# Limits for AC Common Mode Voltage for C2M

**IEEE 802.3ck Task Force**  
**Telephonic Conference**

**May 25, 2022**

- **Contribution in support of following C2M common mode noise comments on 802.3ck D3.2**
  - Comment R2-8 TP1a common mode output limits
  - Comment R2-9 TP4 common mode output limits
  - Comment R2-21 TP4 common mode output limits
  - Comment R2-22 host input common mode limits
  - Comment R2-18 common mode test method
  - Comment R2-20 common mode test method.

# FFT Response of the Common Mode Noise

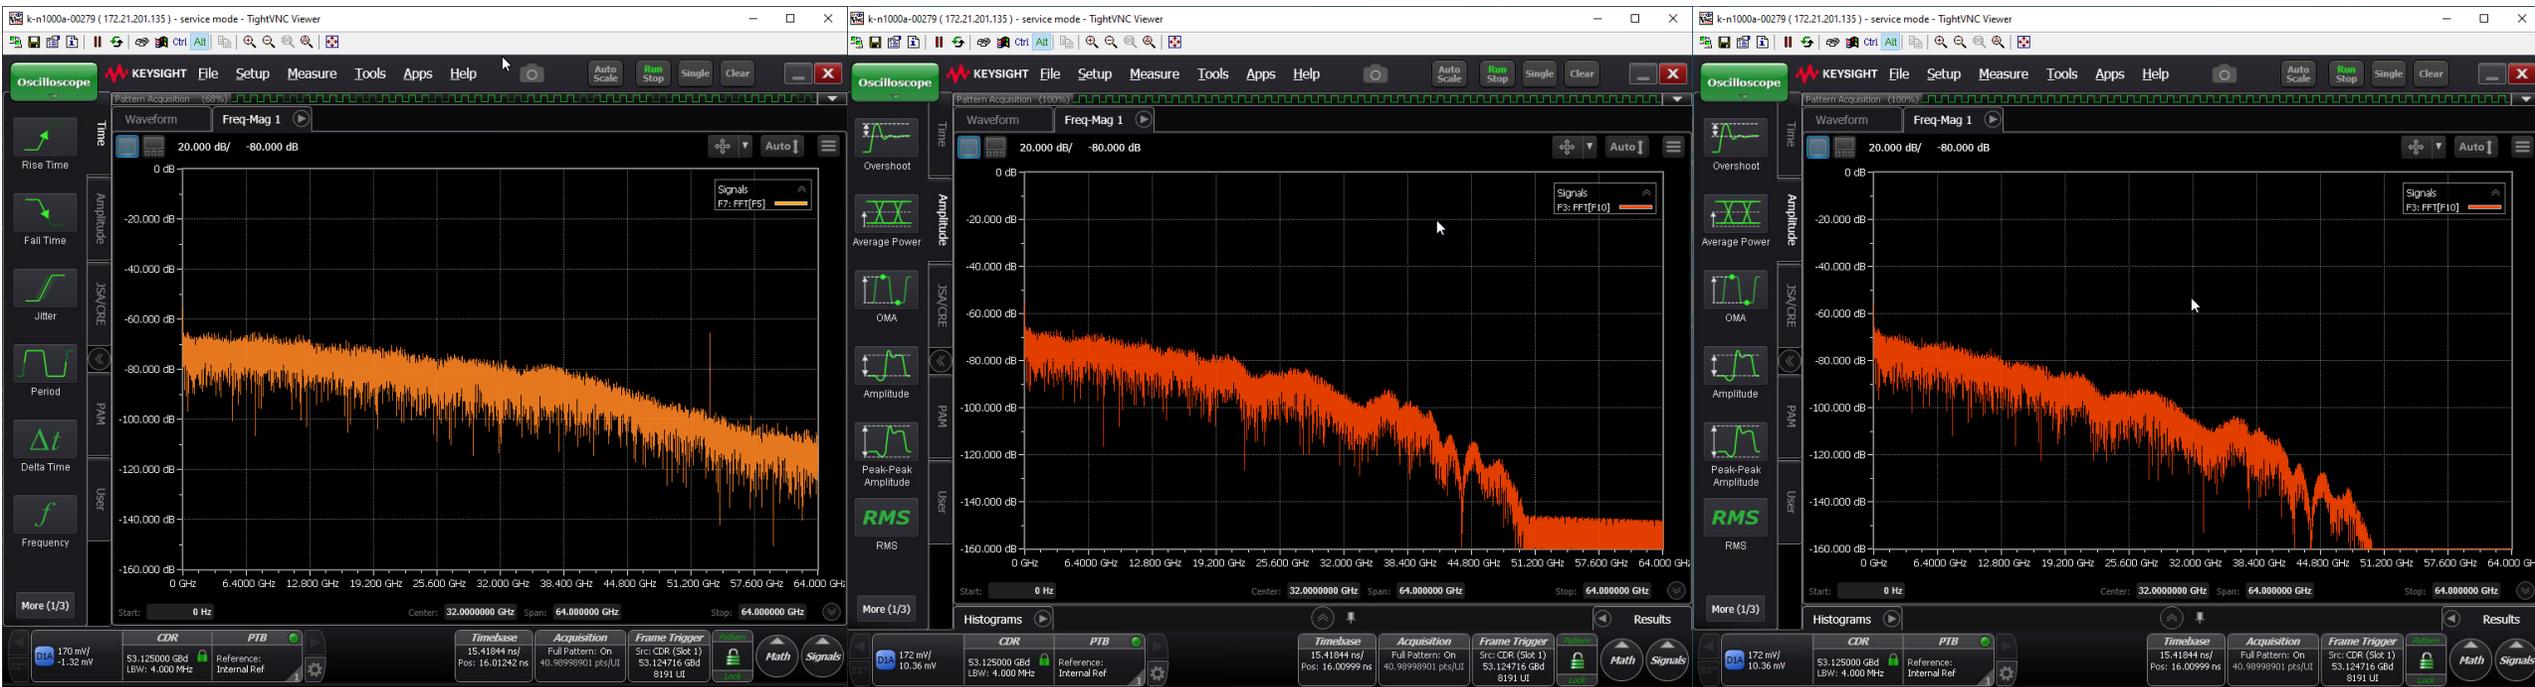
□ FFT response is for 2" and 9" Lim channels the common mode response generally follows differential response

- C2M channels [lim\\_3ck\\_adhoc\\_01\\_073119](#)
- Measured on equivalent time scope without any filters.
